**DOCUMENT 00 90 00
ADDENDUM**

ADDENDUM NO. [1] Date: August 14, 2019

**RE: LANESBORO PUBLIC SCHOOLS
 ADDITION AND REMODEL
 100 KIRKWOOD ST EAST
 LANESBORO, MN 55949
 HSR 18063**

**FROM: HSR Associates, Inc
 100 Milwaukee Street
 La Crosse, WI 54603
 (608) 784-1830**

P100

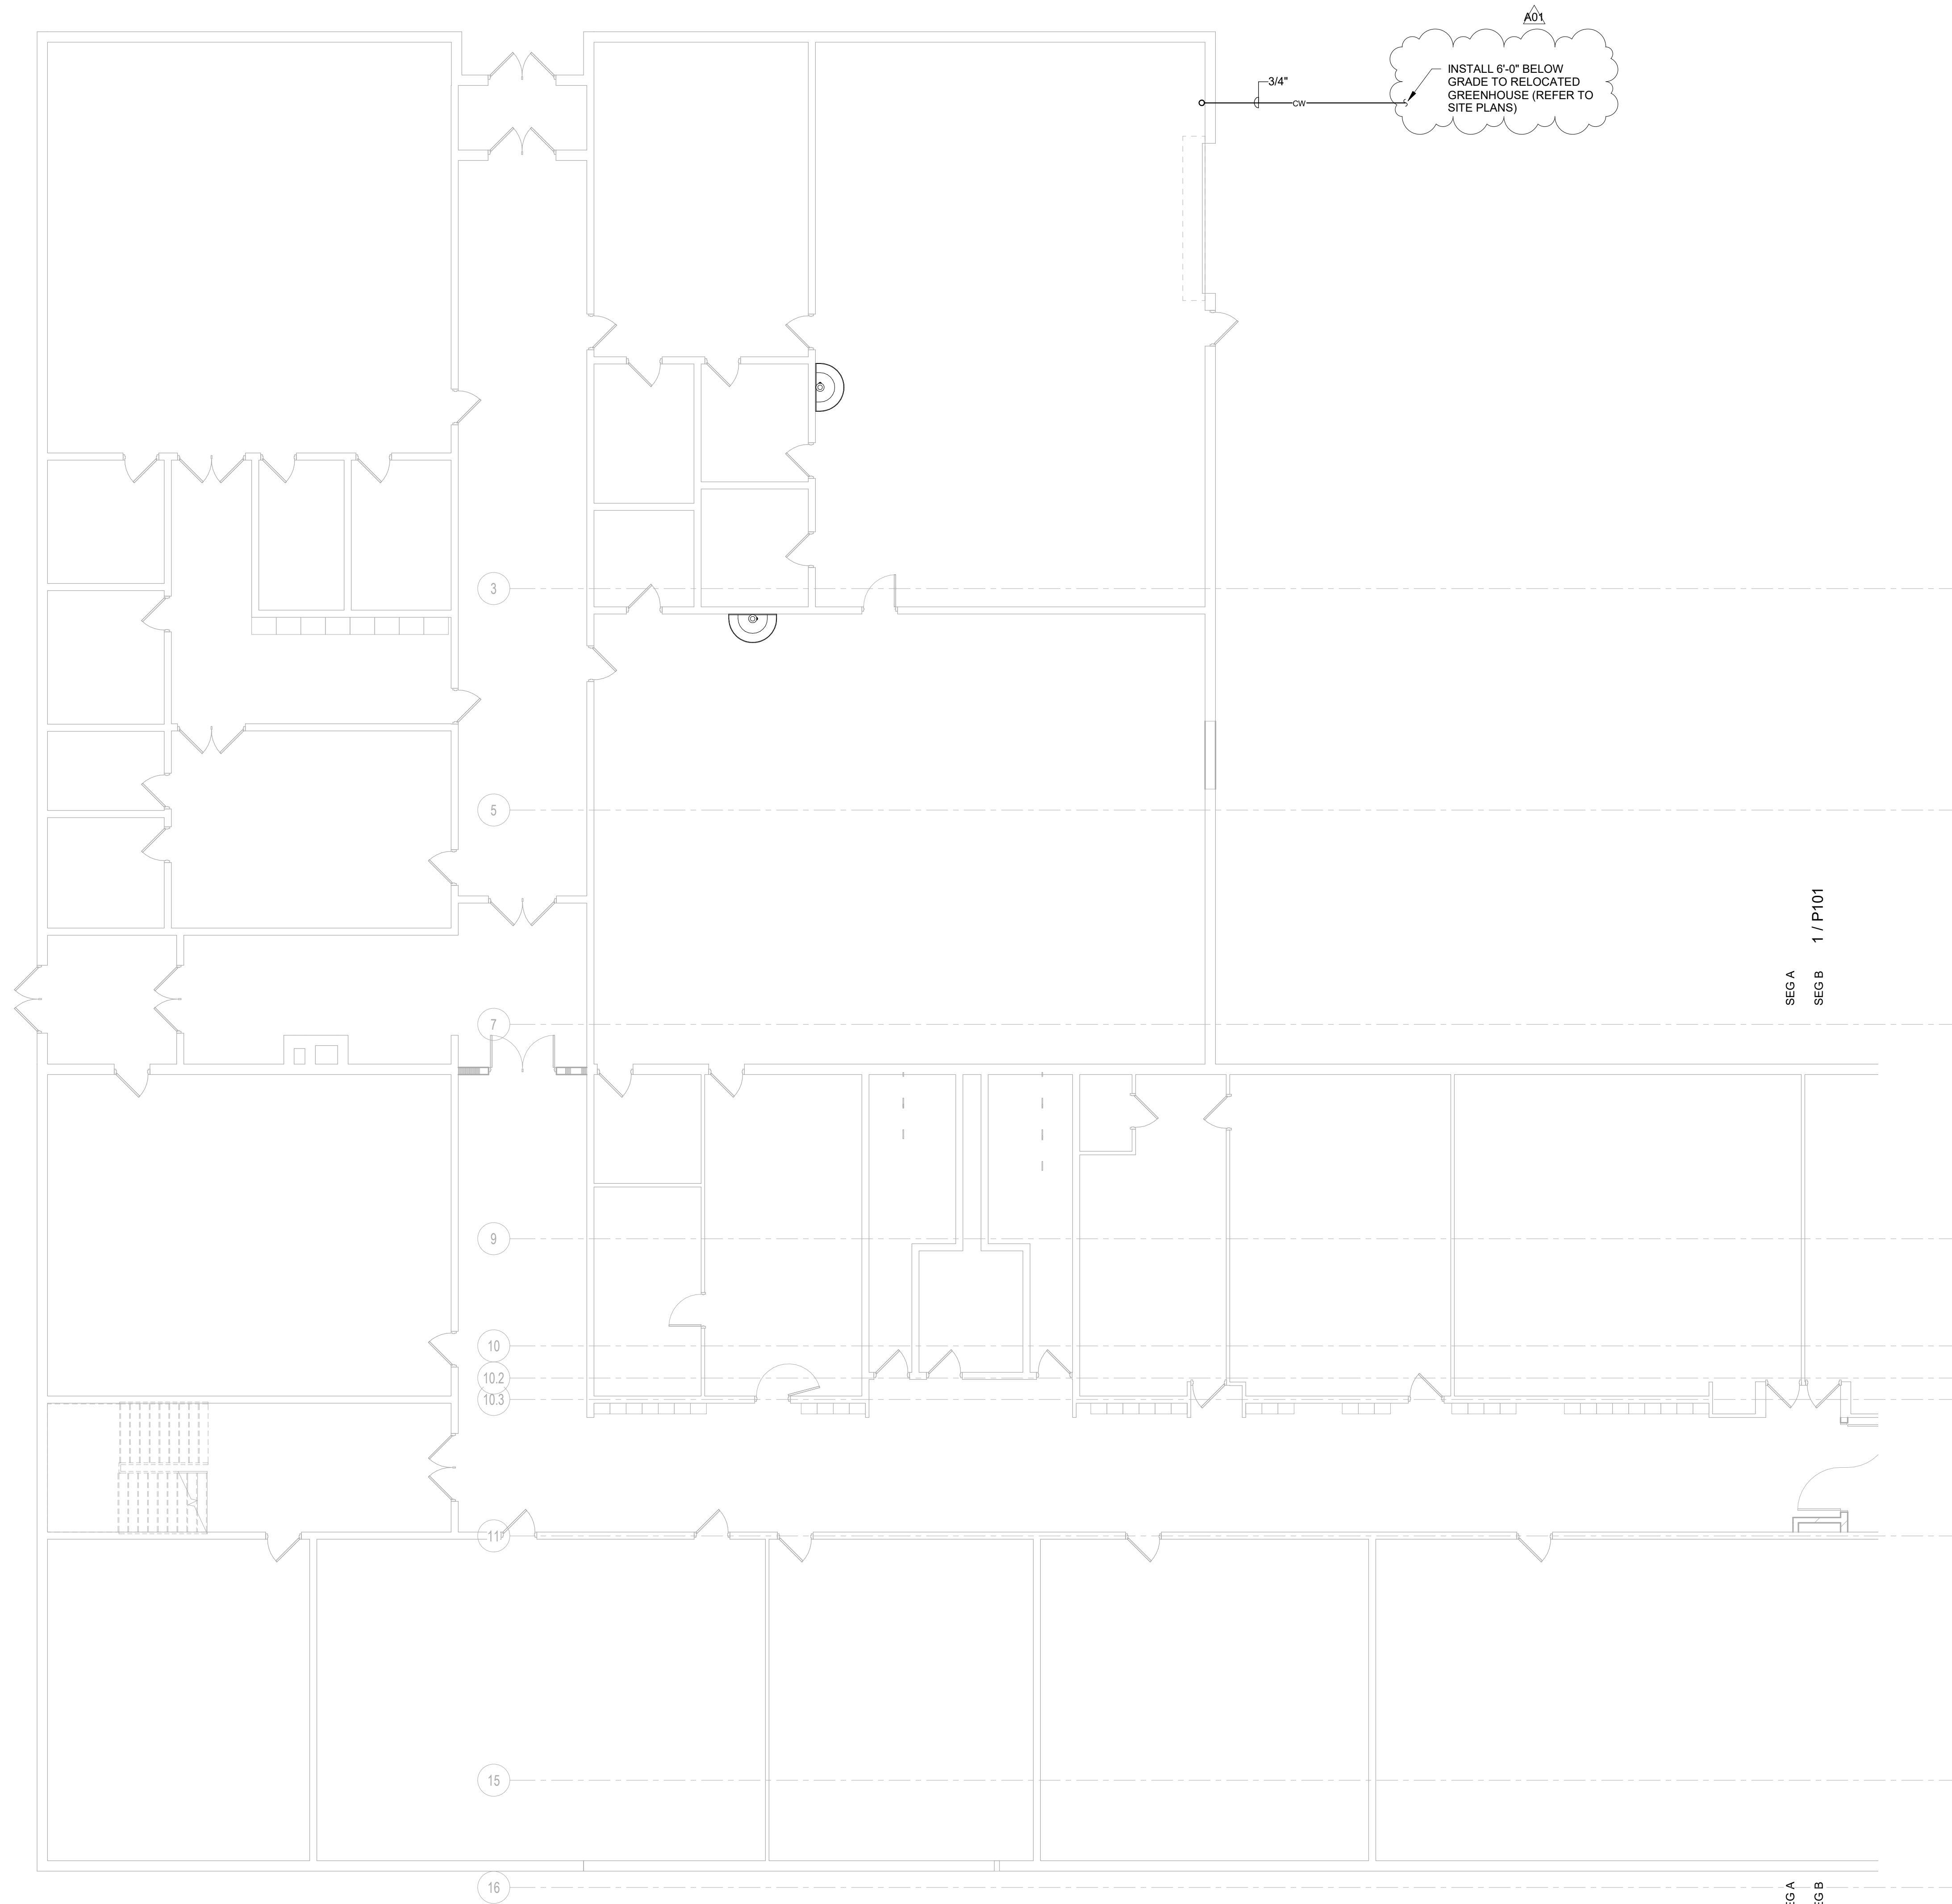
- b. Add note to cap piping at nearest active main, as shown.
 - c. Demolish sink in existing Storage room 218A.
30. Sheet P100 UNDERFLOOR – SEGMENT A – PLUMBING 30 x 42 attached hereto

- a. Revisions clouded on Drawing.
 - b. Revise note on water to green house, as shown.
31. Sheet P101 UNDERFLOOR – SEGMENT B – PLUMBING 30 x 42 attached hereto

P101

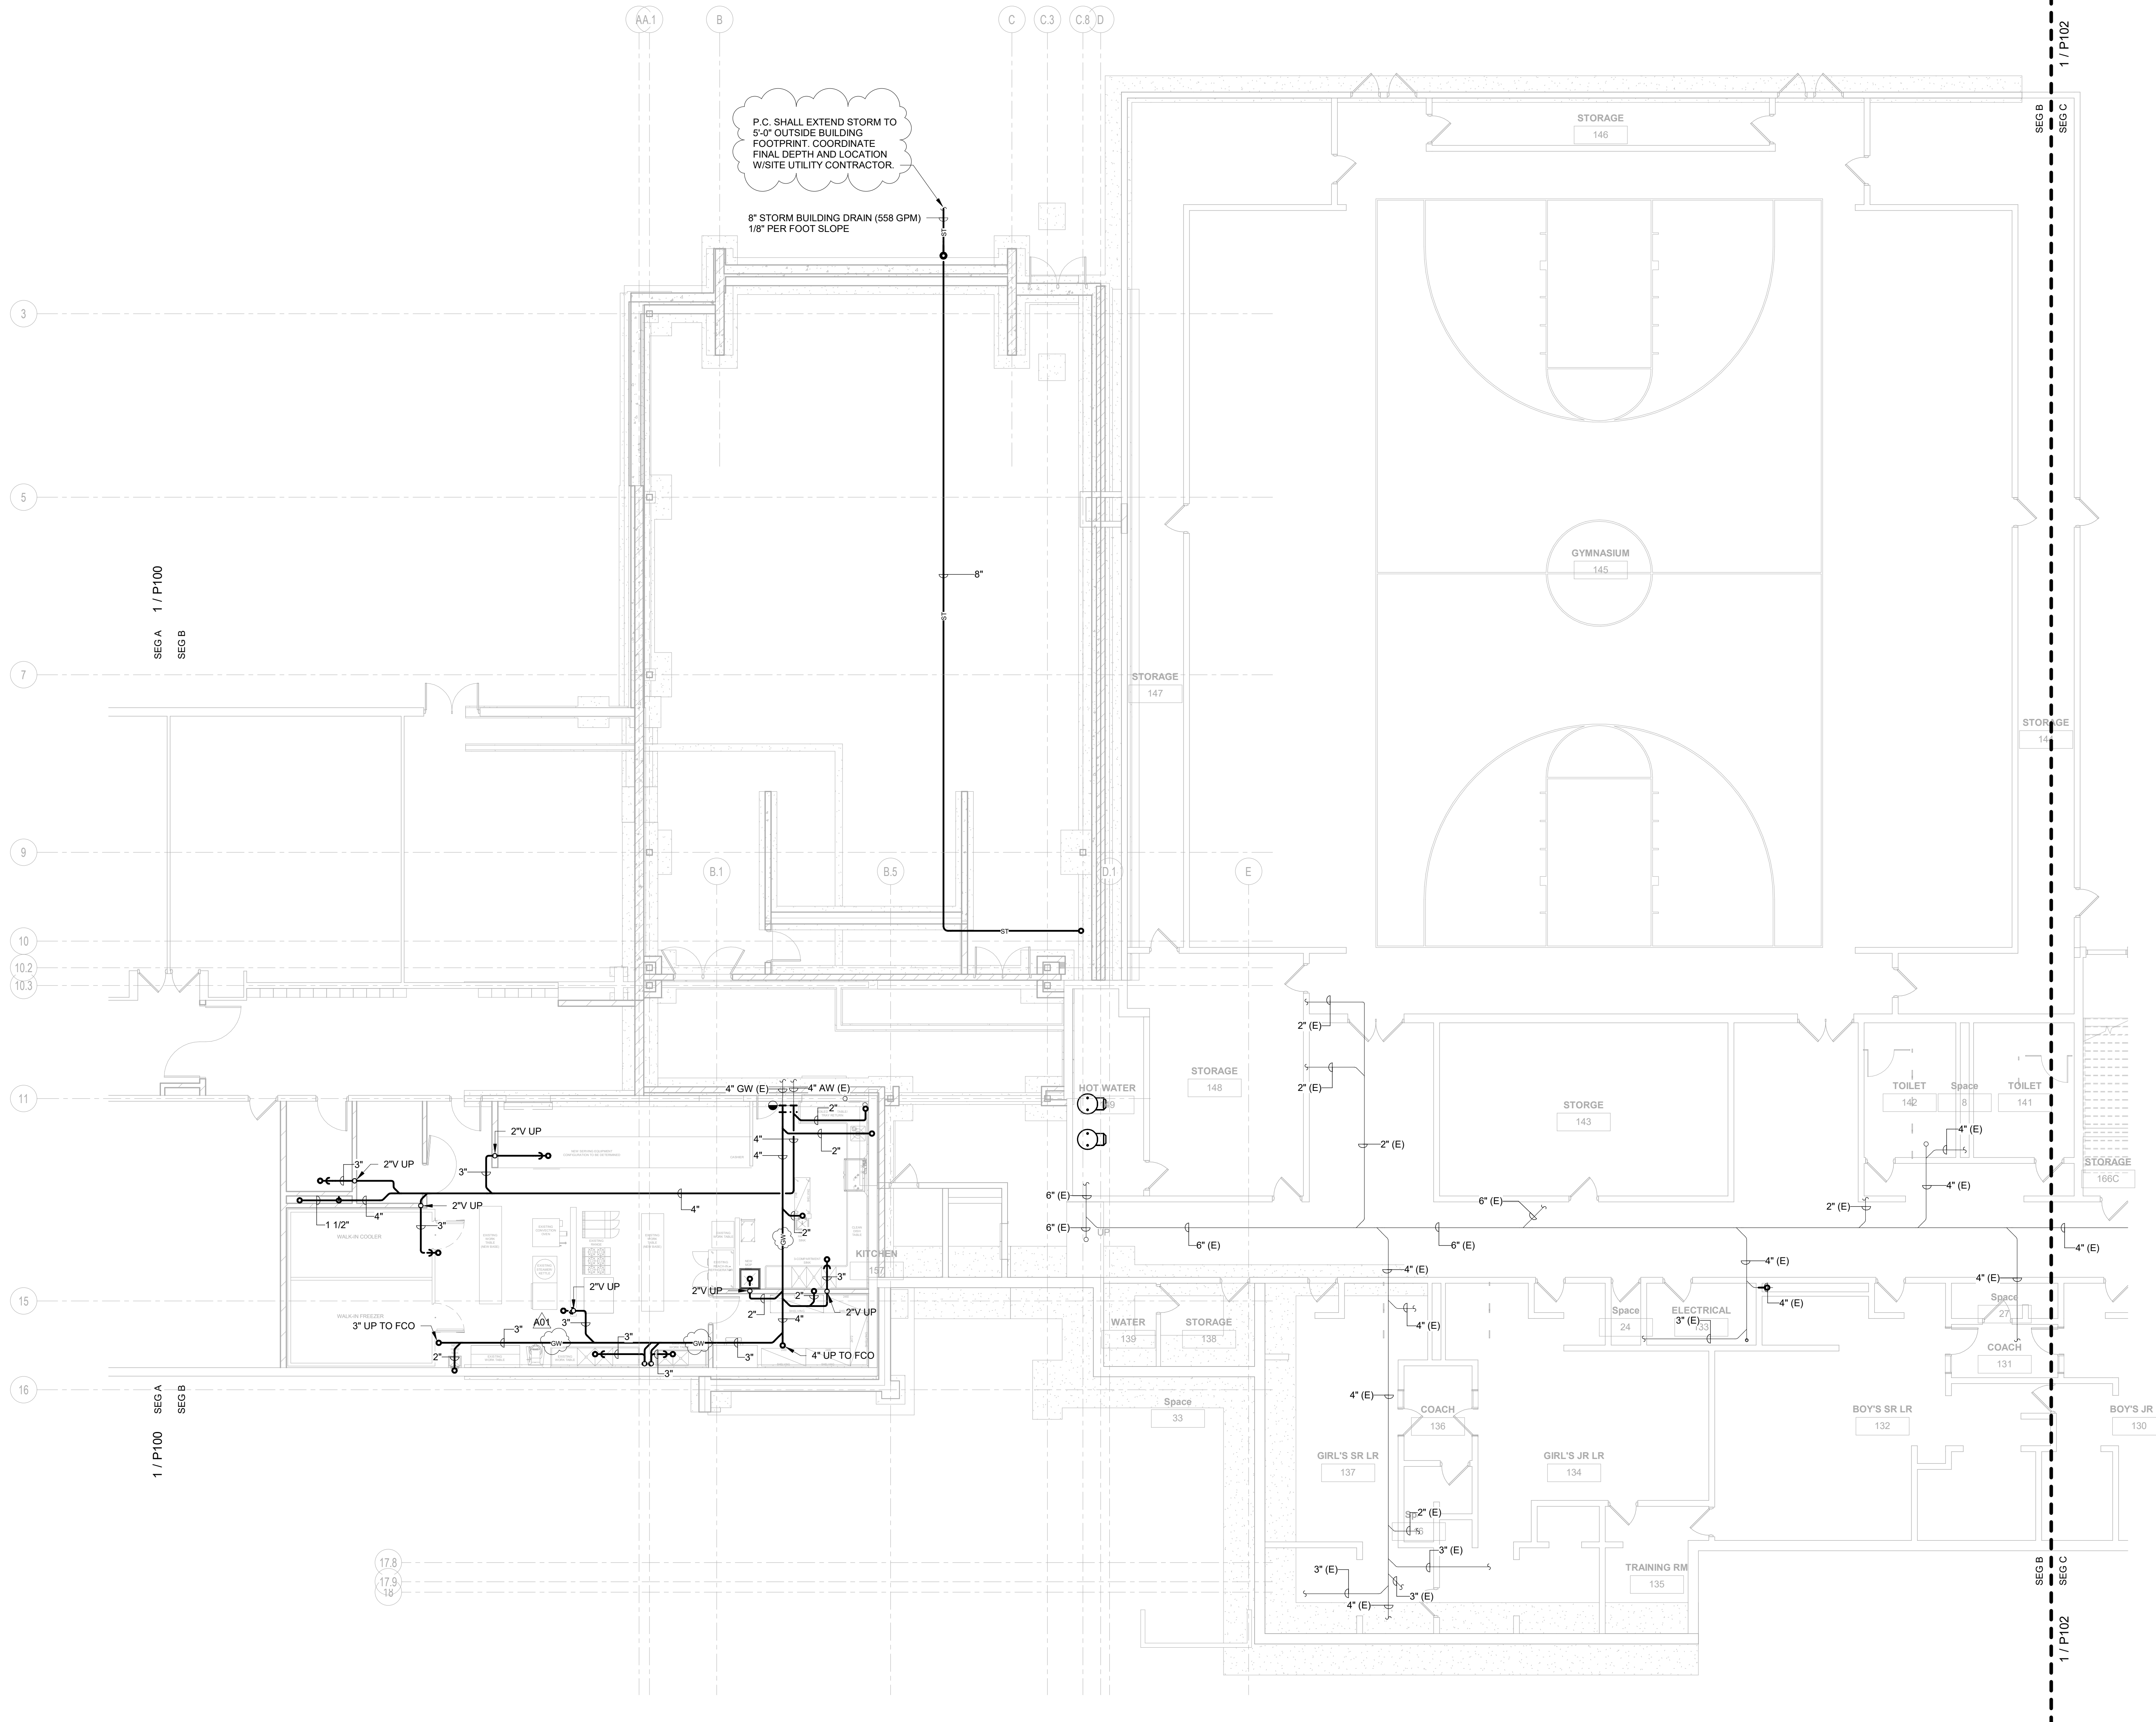
- a. Revisions clouded on Drawing.
 - b. Revise note on storm drain, as shown.
 - c. Revise waste to Grease Waste under Kitchen, as shown.
32. Sheet P102 UNDERFLOOR – SEGMENT C – PLUMBING 30 x 42 attached hereto

P104

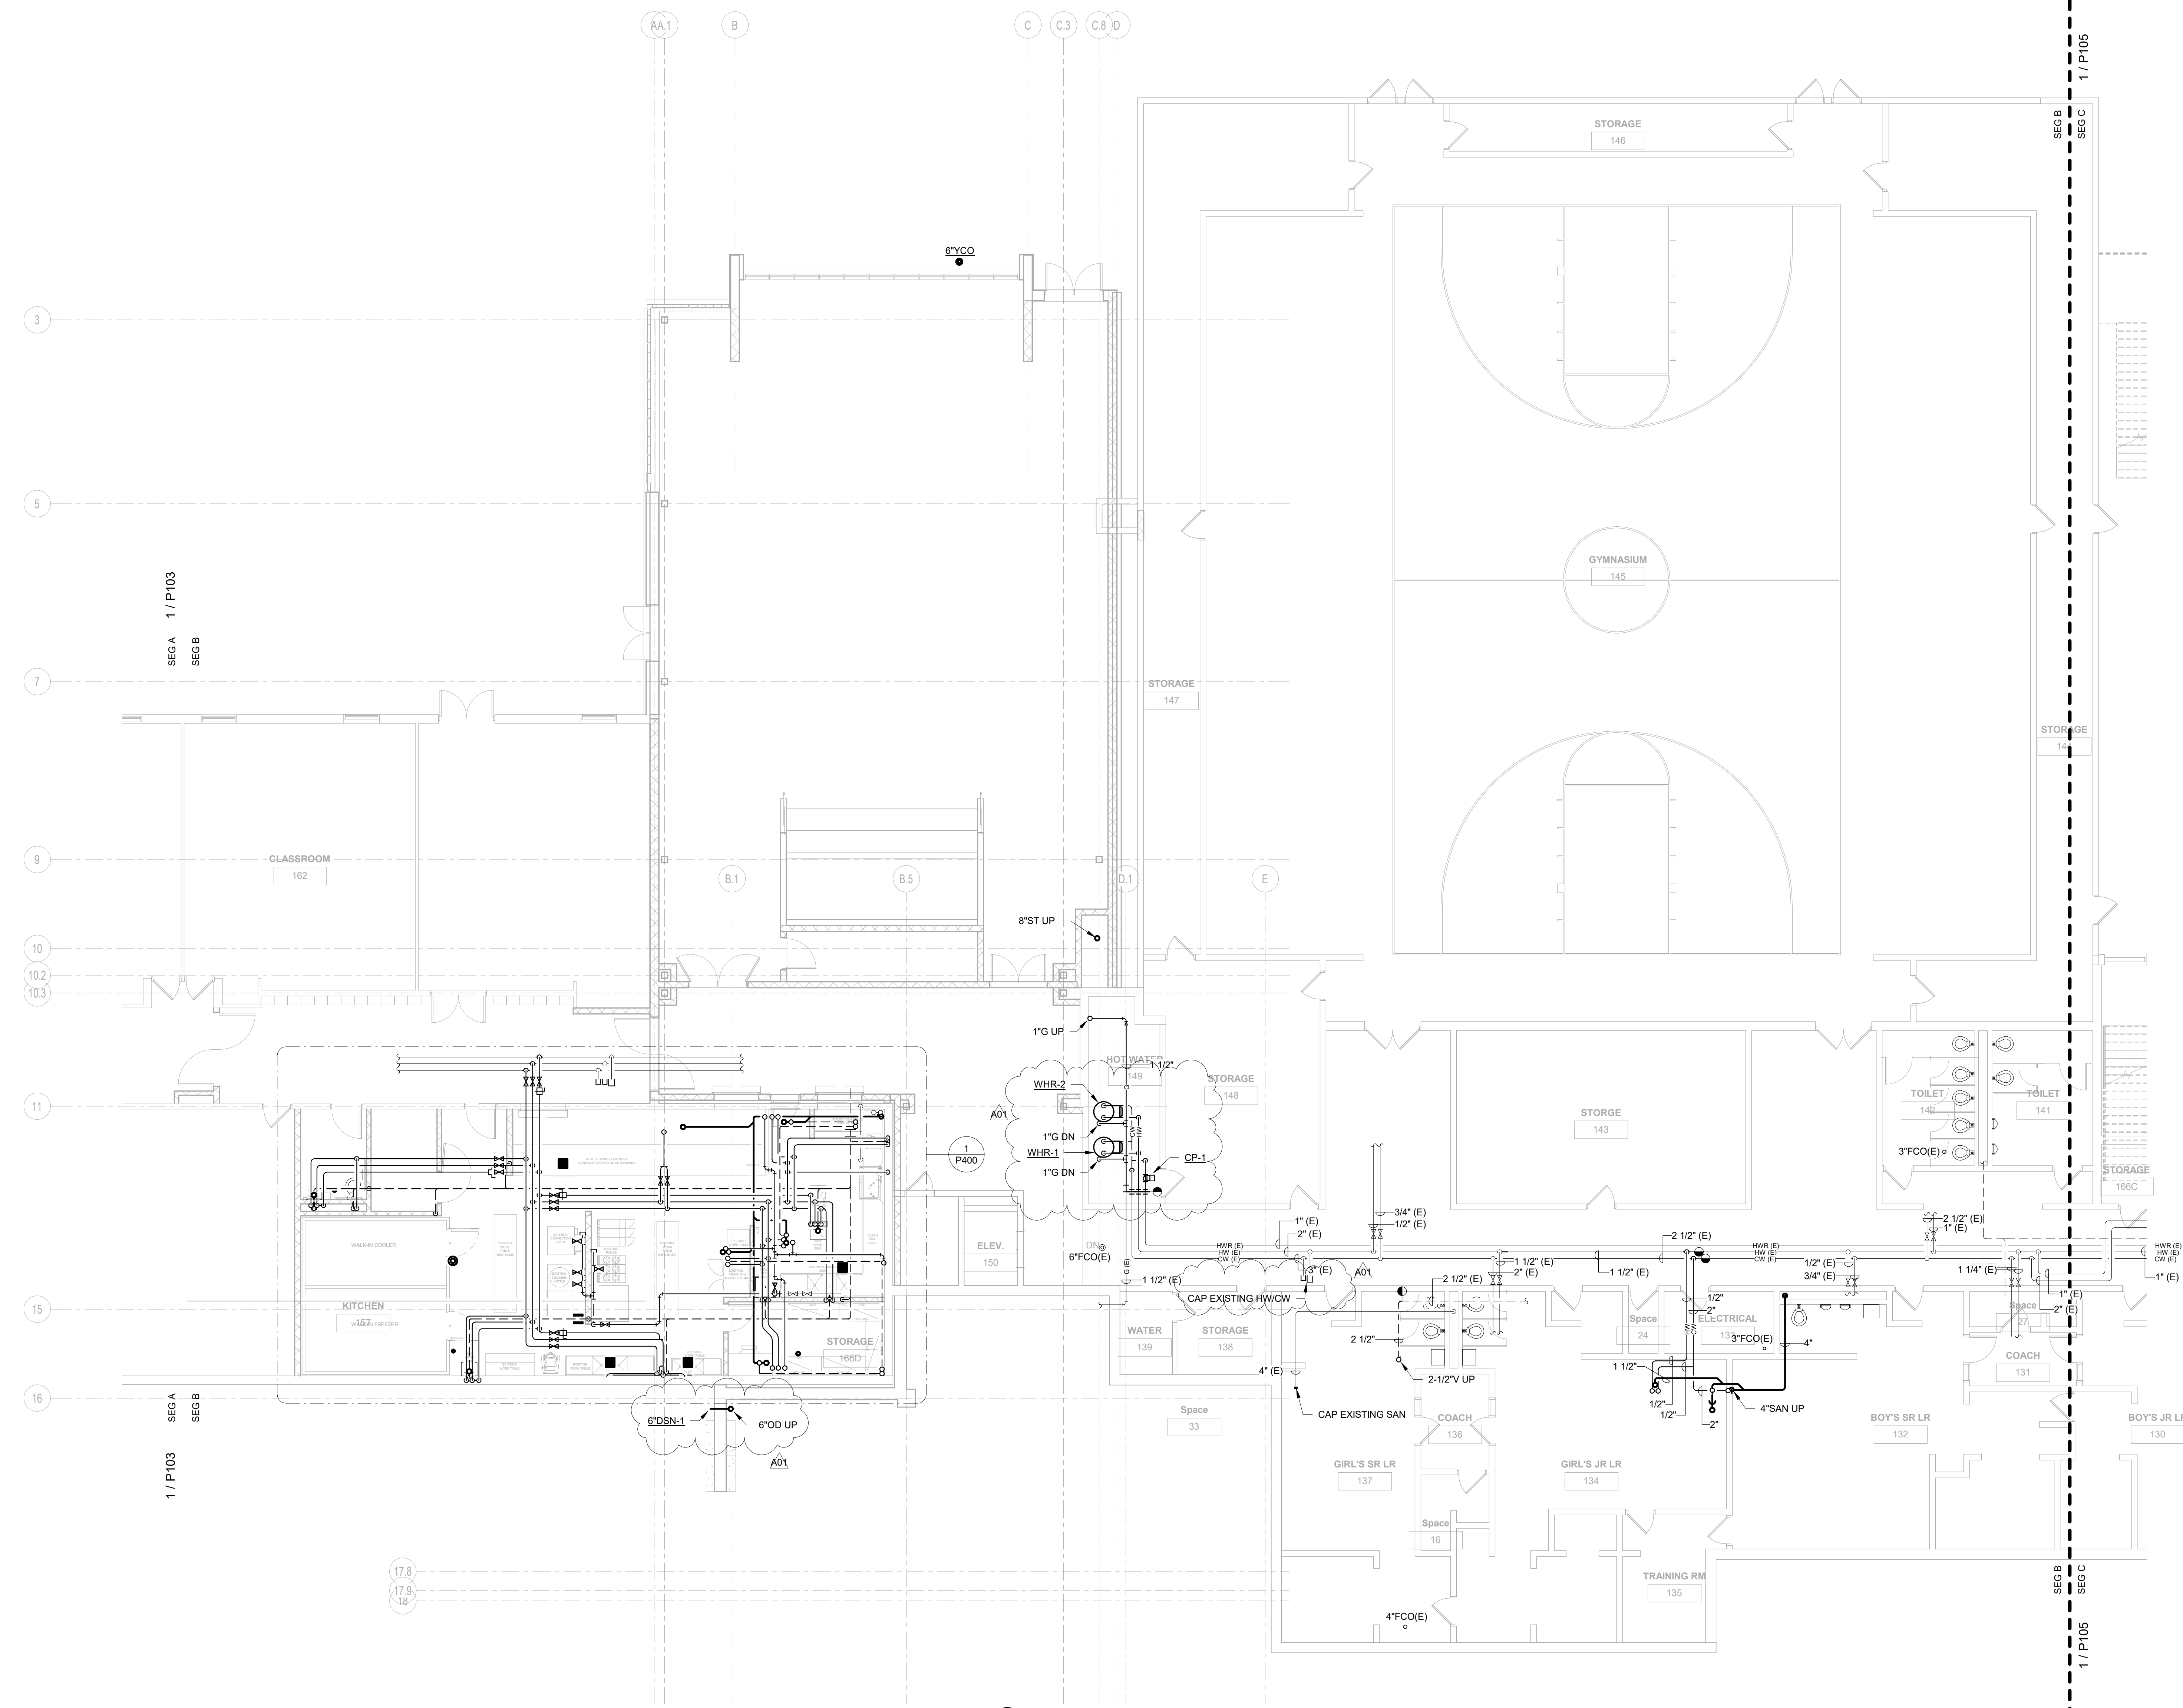
33. Sheet P104 LOWER LEVEL – SEGMENT B – PLUMBING 30 x 42 attached hereto
 - a. Revisions clouded on Drawing.
 - b. Add pipe sizes, as shown.
 - c. Add downspout nozzle fixture callout, as shown.

- d. Revise location to cap water, as shown.
34. Sheet P105 LOWER LEVEL - SEGMENT C – PLUMBING 30 x 42 attached hereto
 - a. Revisions clouded on Drawing.
